Subject: AP1000 Response to Request for Additional Information (SRP 3)

RAI-SRP3.7.1-SEB1-11 R2

# AP1000 TECHNICAL REPORT REVIEW

RAI Response Number: RAI-SRP3.7.1-SEB1-11

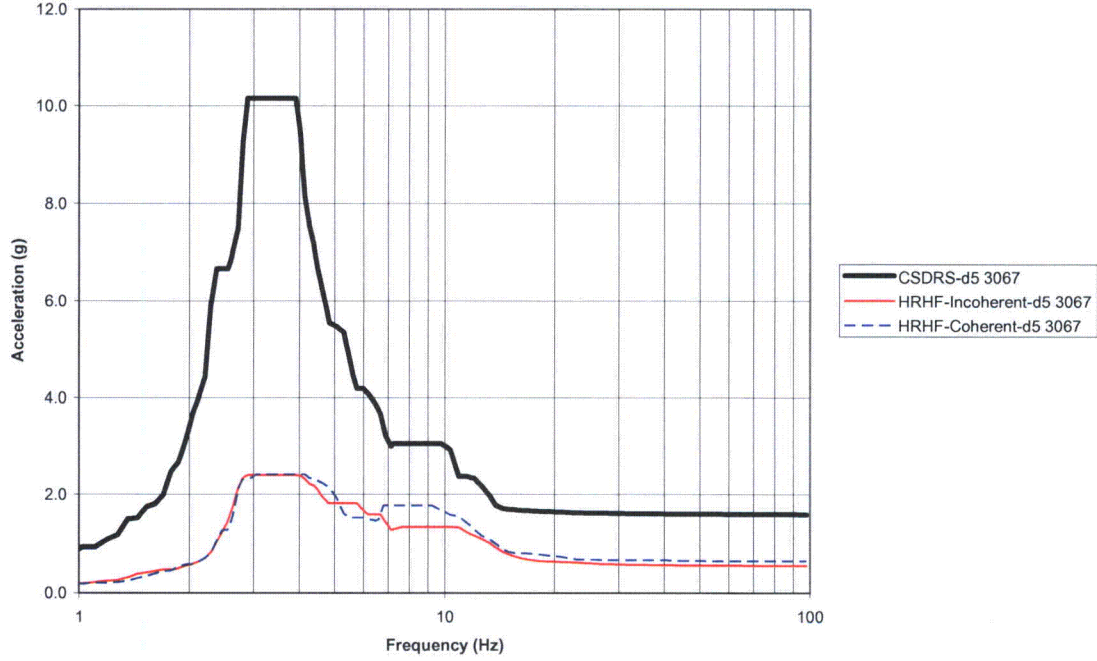
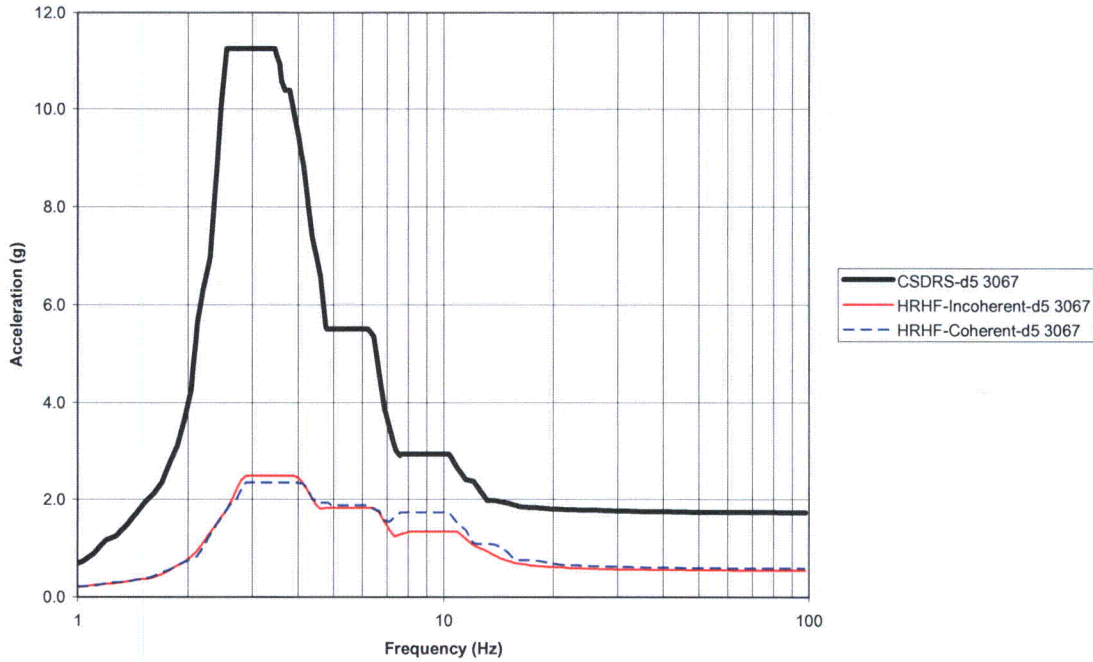
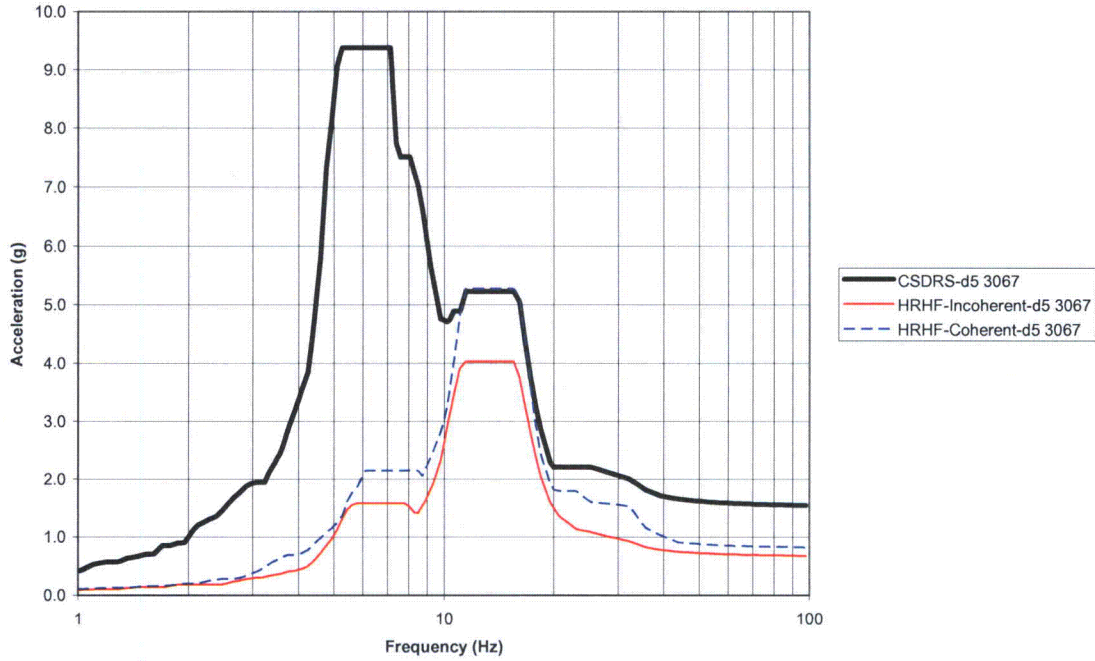
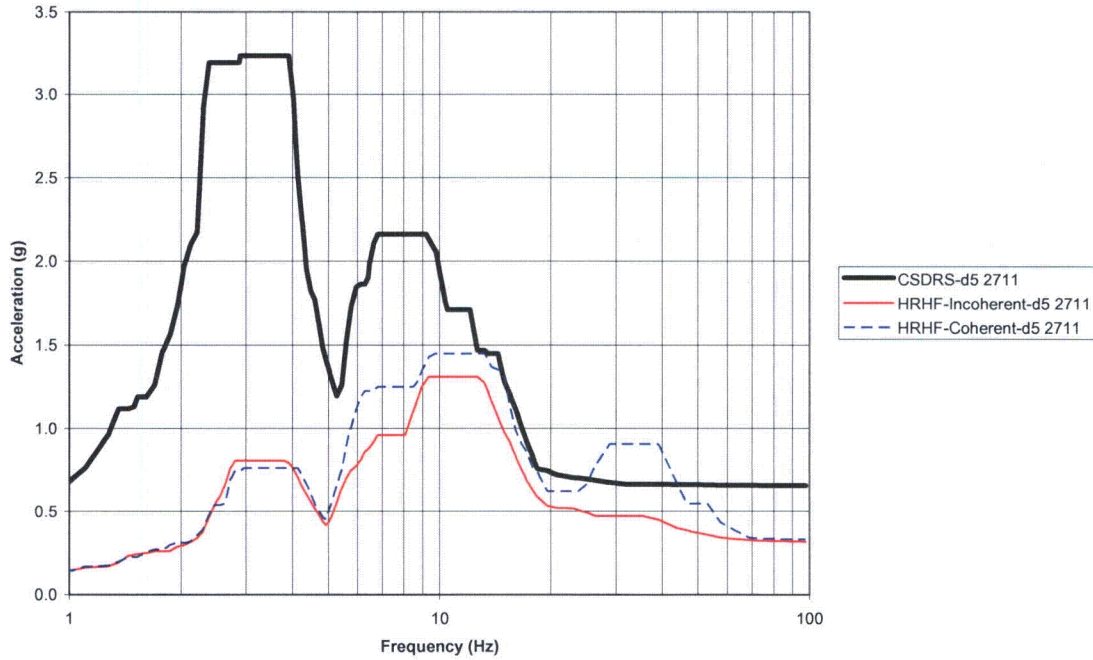
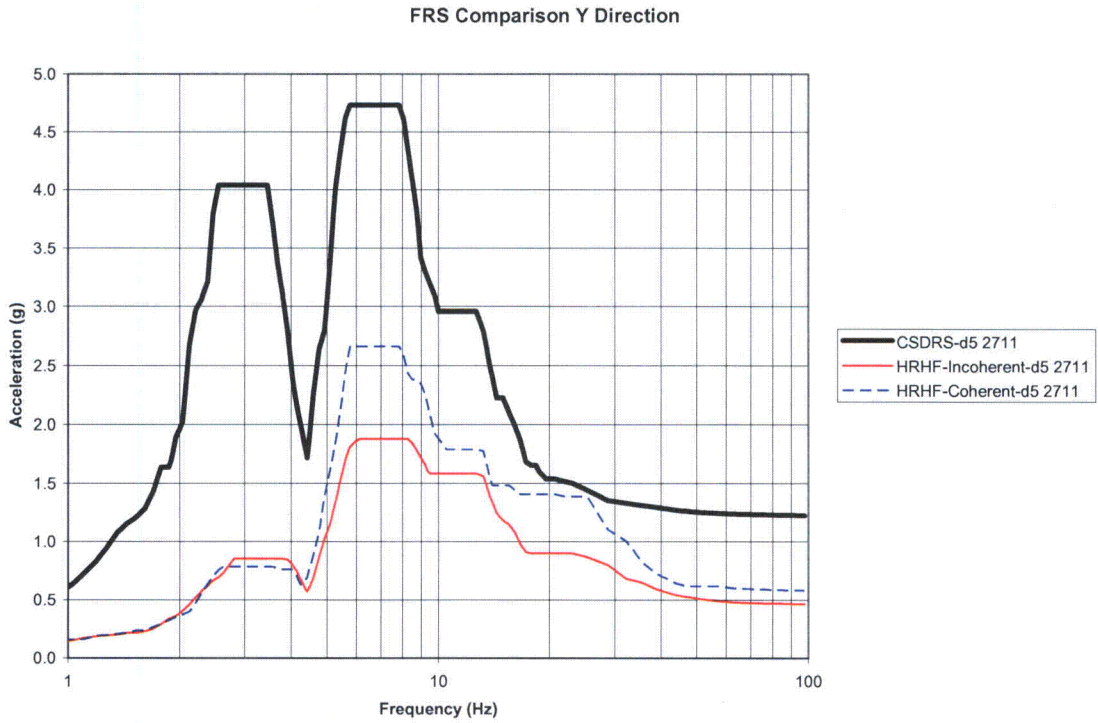
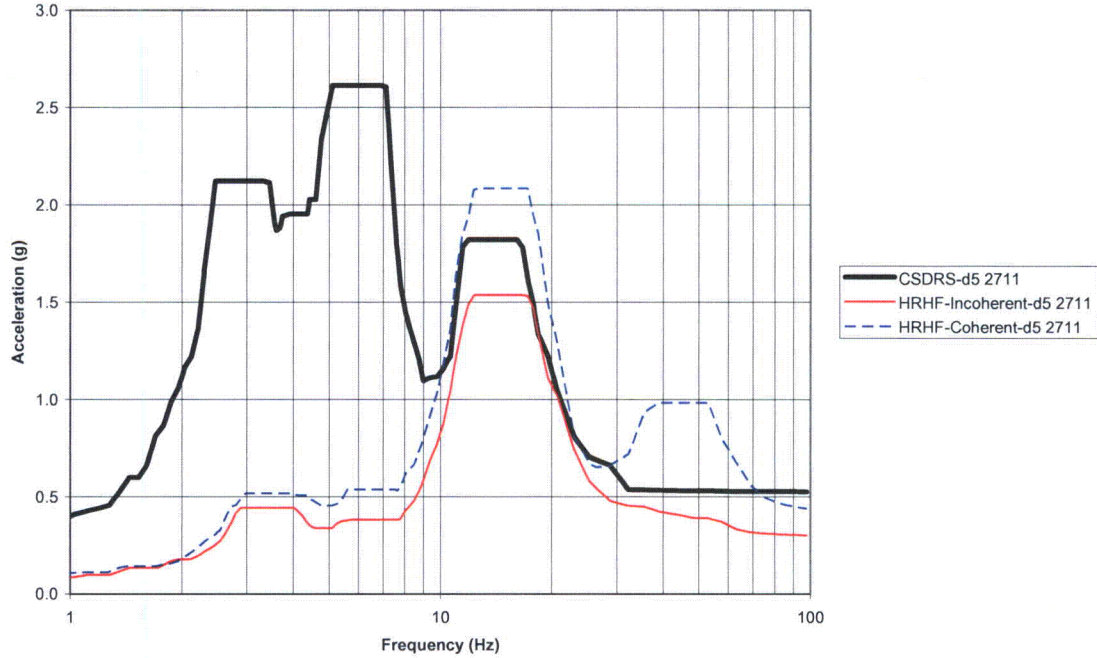
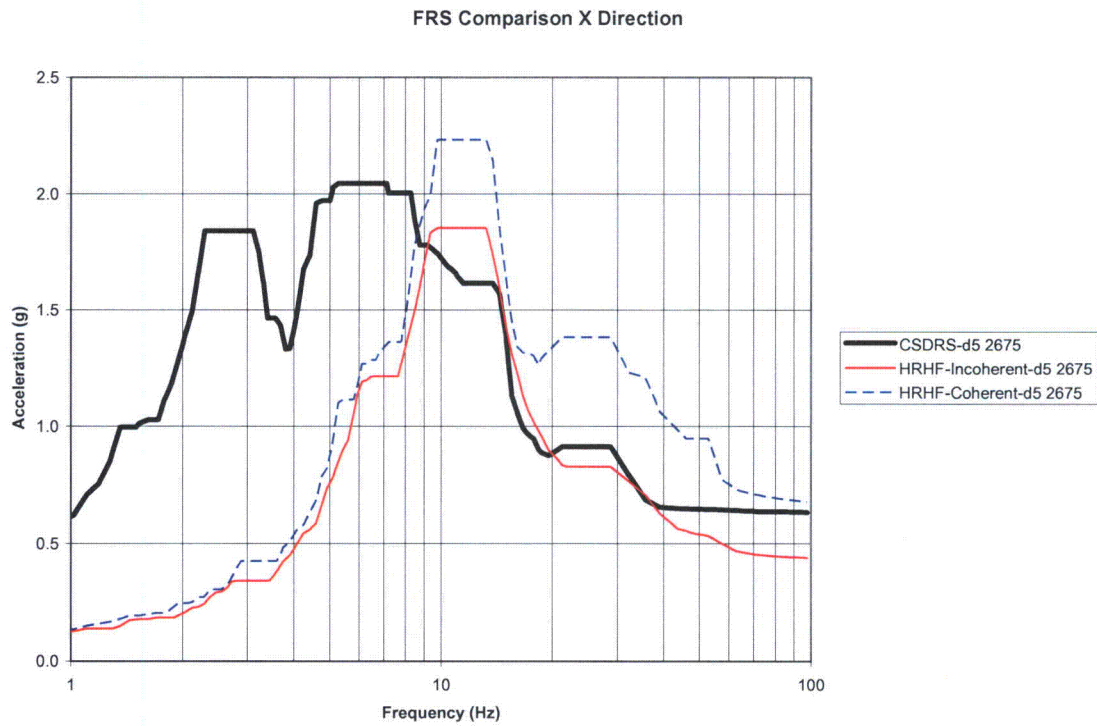
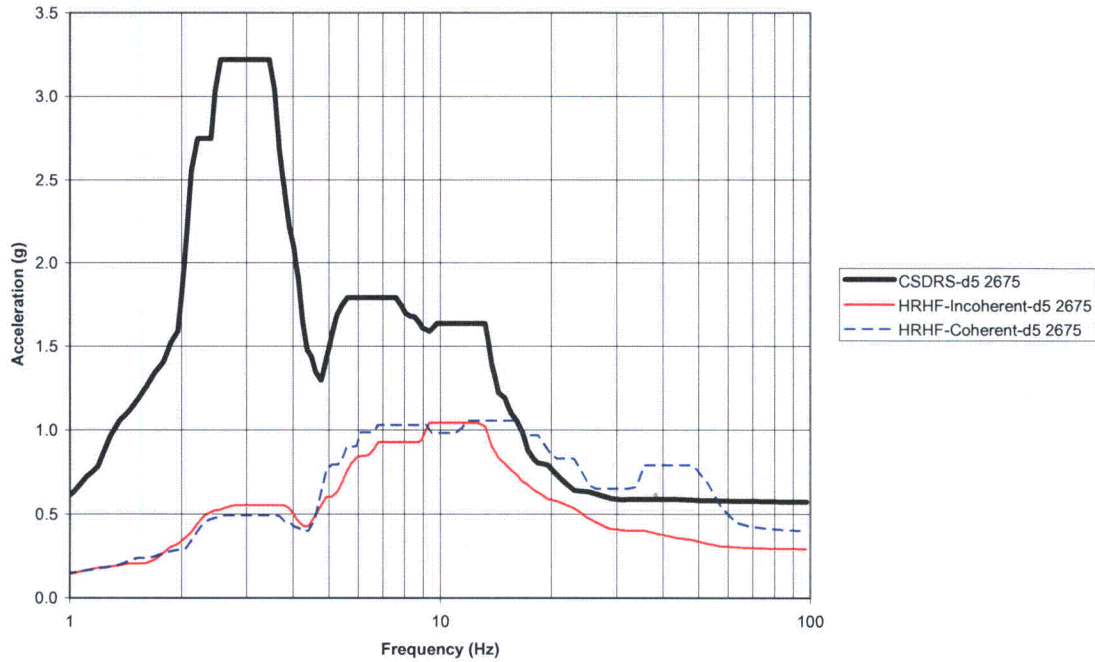
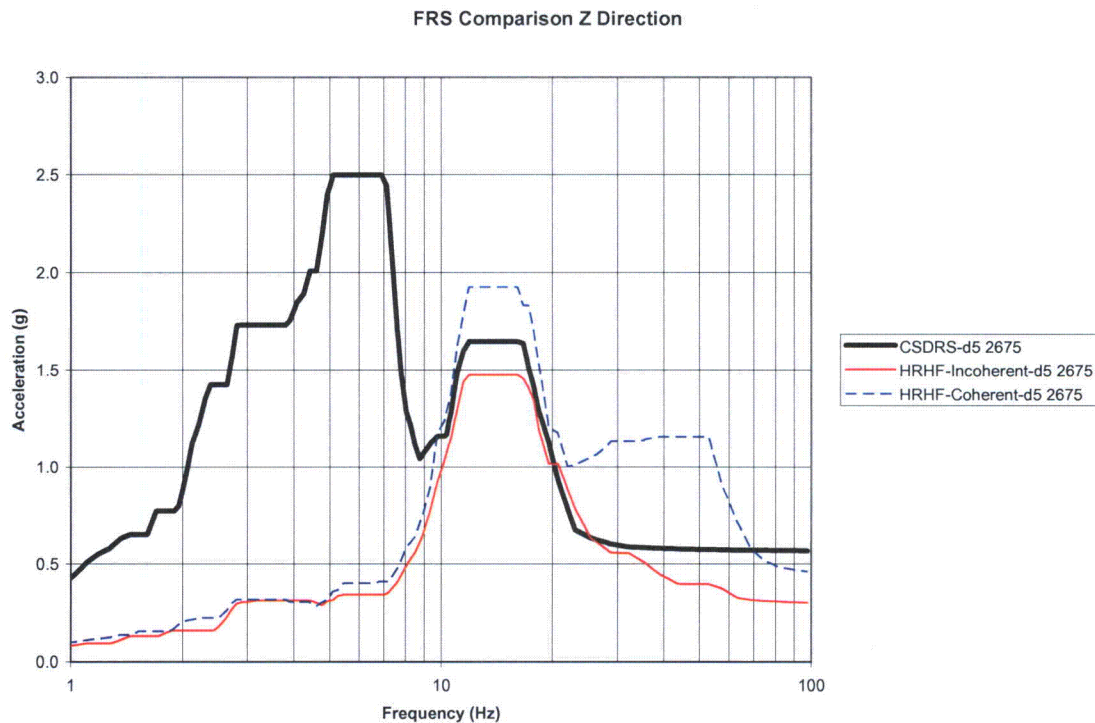
The staff requests that Westinghouse provide additional figures in Section 5.2 TR-115, to include all location/direction combinations presented in the Section 5.1 figures, and to provide a cross-reference between the corresponding 5.1 and 5.2 figures.

The figures provided in Section 5.1 are for comparison of NI10 and NI20 models. The time histories are different from that used in the HRHF evaluation documented in TR-115 as discussed in the Westinghouse response to RAI-SRP3.7.1-SEB01-07. No reduction for incoherency was considered. A representative group of HRHF floor response spectra were developed at locations considered susceptible to the high frequency response for comparison to the CSDRS floor response spectra. Some of these locations are the same or close to those given in Section 5.1. It would not be useful to add additional figures in Section 5.2 since the locations chosen are considered sufficient for comparison. A cross-reference between corresponding 5.1 and 5.2 figures cannot be given since different time histories are used.

In response to the NRC's request to supplement Section 5.2 in the TR-115 during May 19-23, 2008, Westinghouse has provided incoherent and coherent comparison response spectrum for the nodal locations presented in TR-115 Section 5.1. These spectra are presented below in Figure RAI-SRP3.7.1-SEB1-11-1 to RAI-SRP3.7.1-SEB1-11-9 (5% damping).

RAI-SRP3.7.1-SEB1-11-10: Basemat Nodal Locations, Elevation 60.5'

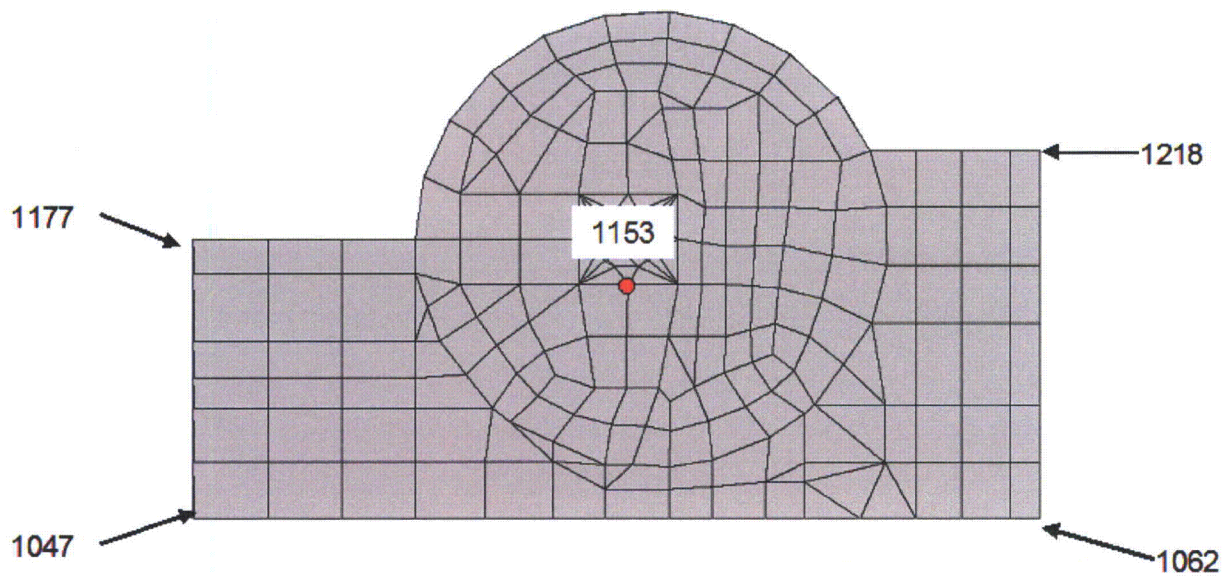
More data, i.e., HRHF response spectra for 5 locations on the basemat (4 locations at 4 corner and center) comparison of coherent at 5 nodes, 25 samples of incoherent and average of 25 incoherent response spectra.

Following the NRC Audit of AP1000 Seismic Design the week of April 13-17, 2009, the NRC has requested additional HRHF FRS at the four corners and center of the Nuclear Island basemat. The nodal locations of the response spectra comparisons have been provided in a plot shown in Figure RAI-SRP3.7.1-SEB1-11-10. A comparison of the SRSS combined X, Y and Z directions for incoherent simulations, average incoherent and coherent FRS are shown in Figures RAI-SRP3.7.1-SEB1-11-11 through RAI-SRP3.7.1-SEB1-11-25. The plots provided show a general reduction in the 25 incoherent simulations when compared to the coherent response in the higher frequencies. At lower elevations, the incoherent simulations exceed the coherent responses in the z-direction around the 10-20 Hz range; these exceedances do not exist at higher elevations as seen in Figures RAI-SRP3.7.1-SEB1-11-1 through RAI-SRP3.7.1-SEB1-11-9.
